Pre-Application Meeting PRE 23-20 Follow-up Notes

Tuesday, November 7, 2023 at 10:00 a.m.

Thank you for joining staff for pre-application meeting PRE 23-20 to discuss the proposal by Immanuel Lutheran Church for annexation, rezoning to Nodal Single Family Residential (RSN), partition, and planned unit development (PUD) of approximately 8.10 acres with no street address ([Tax Lot 052W130000301](#)) at the southeast corner of Evergreen Road & Linfield Avenue into a church with accessory uses, including non-profit commercial offices in an outbuilding, on a northwest lot of approximately 4.4 acres, providing a southwest tract of improved common area / open space of approximately 1.7 acres, and leaving approximately 2 acres undeveloped as an east lot.

SHEET TITLE
 3D: Isometric View

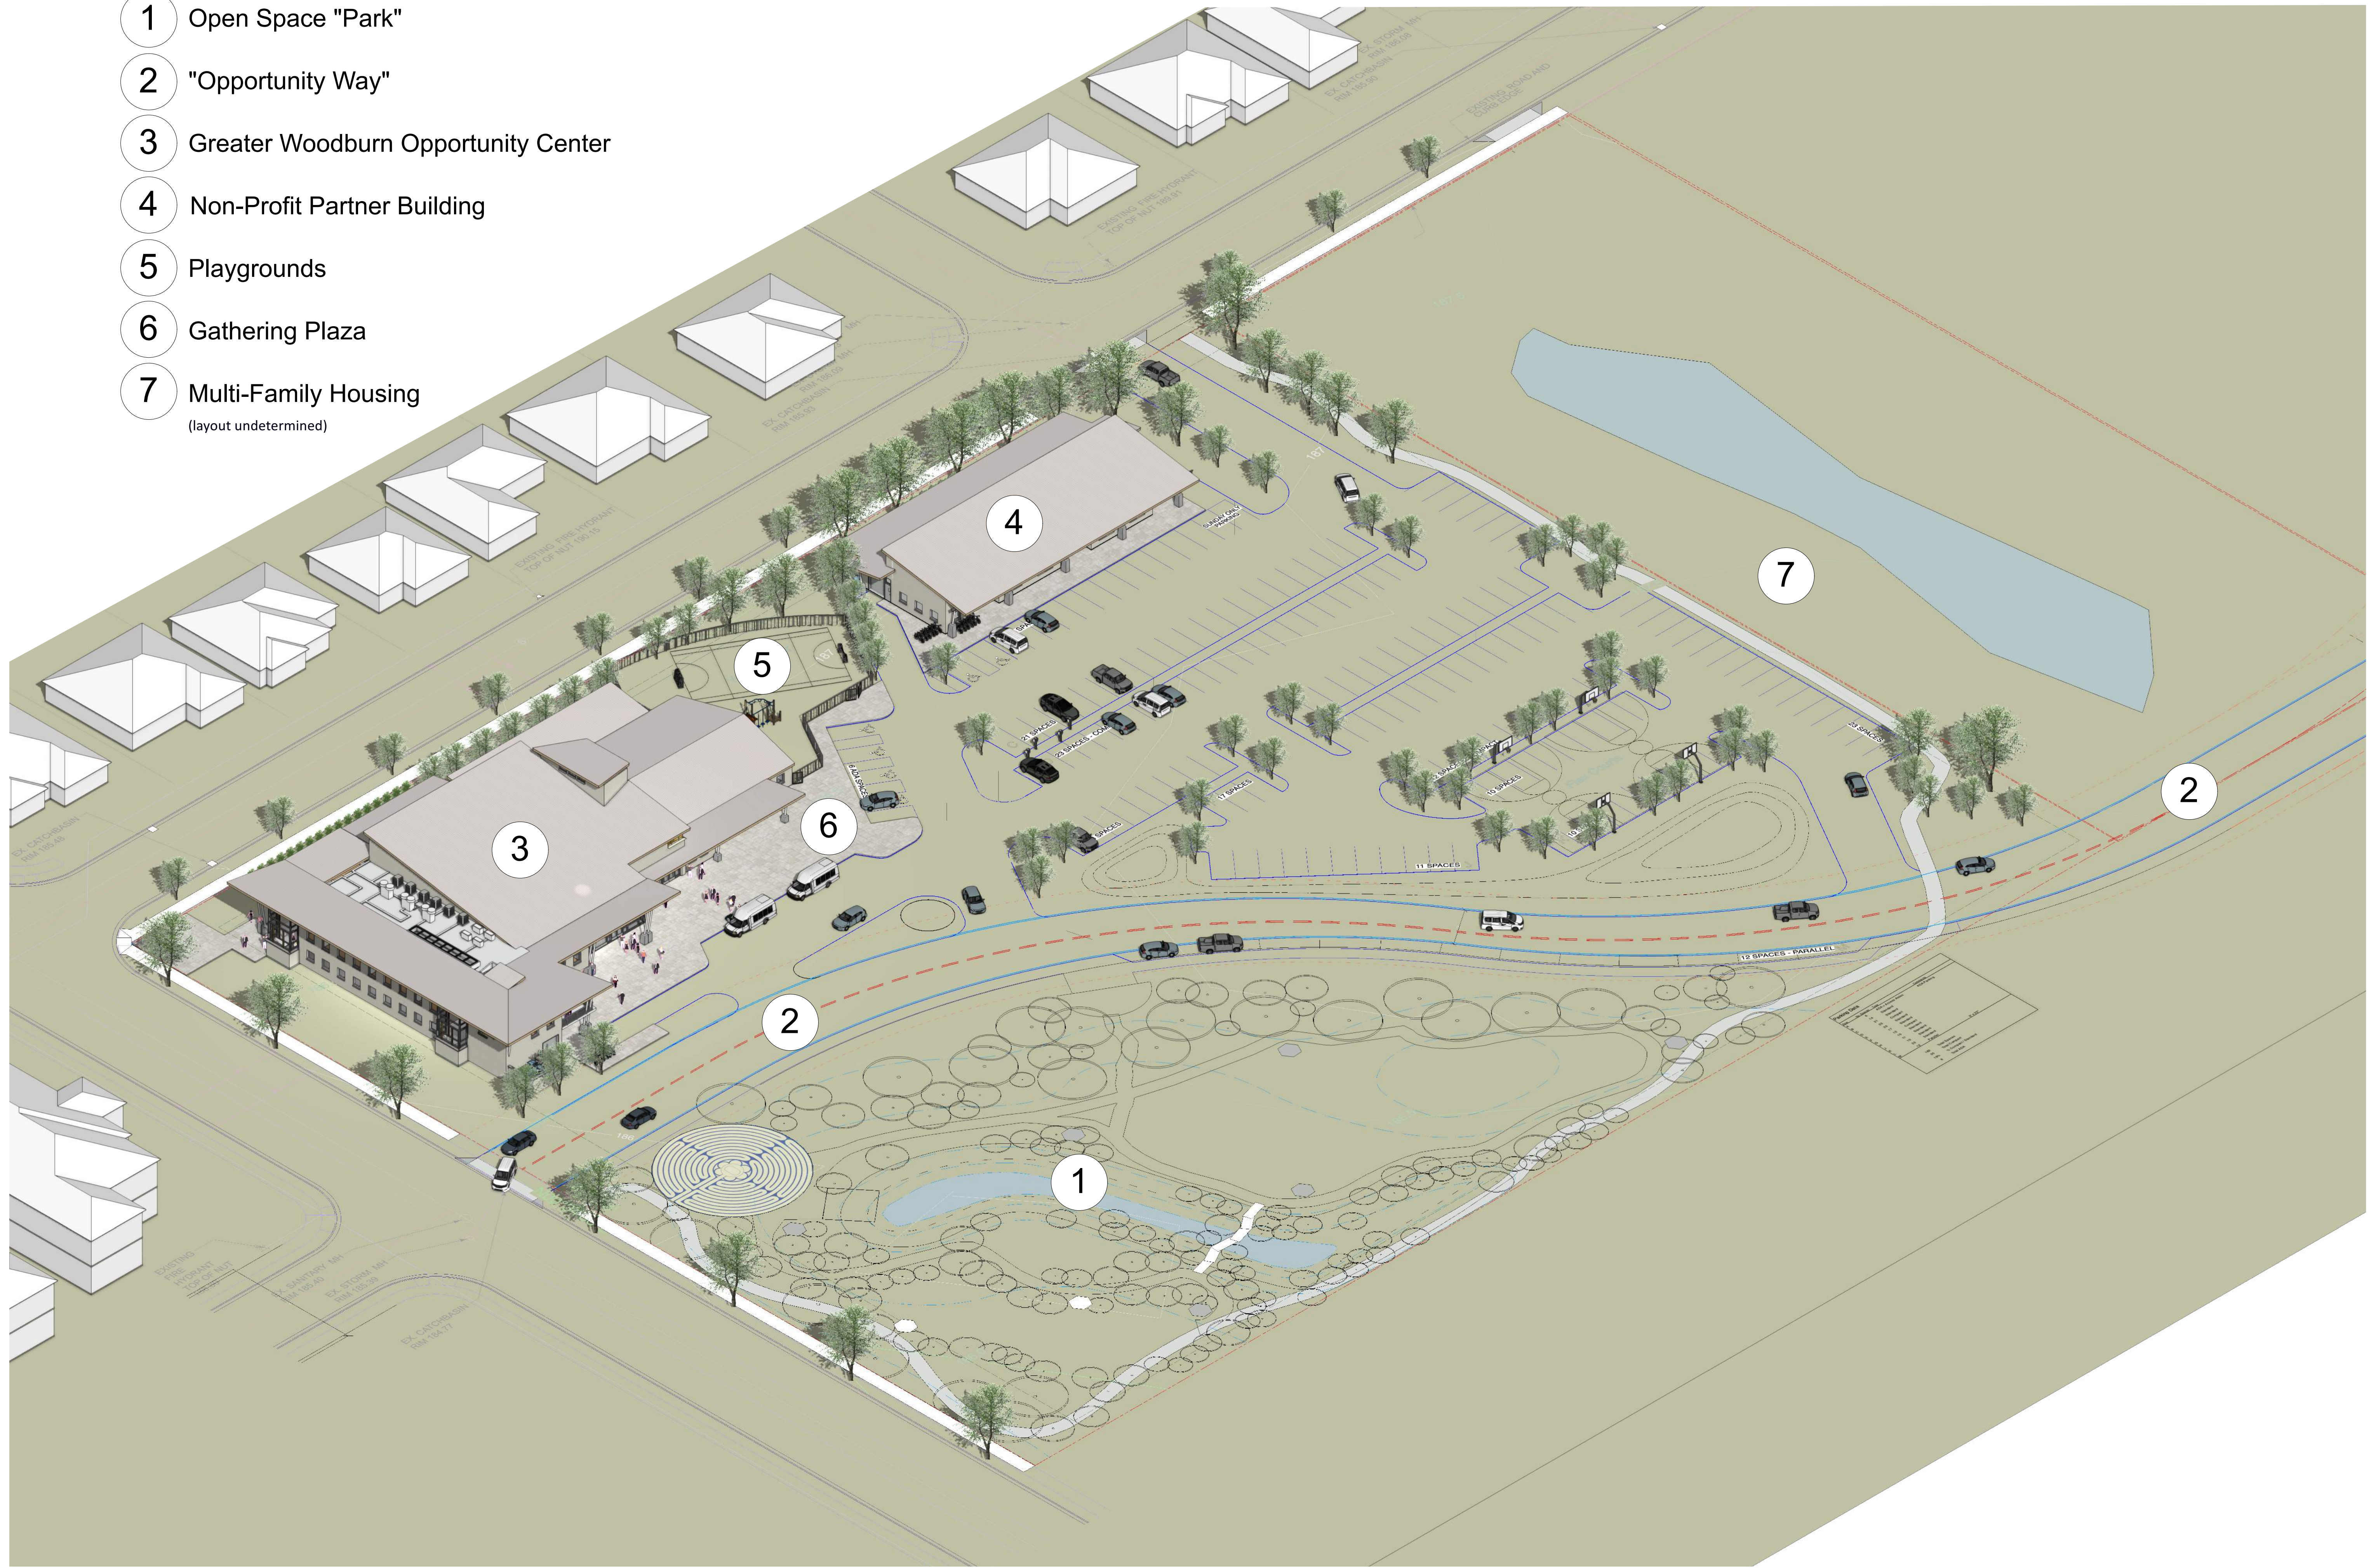
- An 8’ wide public utility easement will be needed on the north side of the new private drive (Opportunity Way).”
 - Max Hepburn, PE, Land Development Engineering & Permits Supervisor, Marion County Public Works Engineering Division, (503) 566-4157, mhepburn@co.marion.or.us
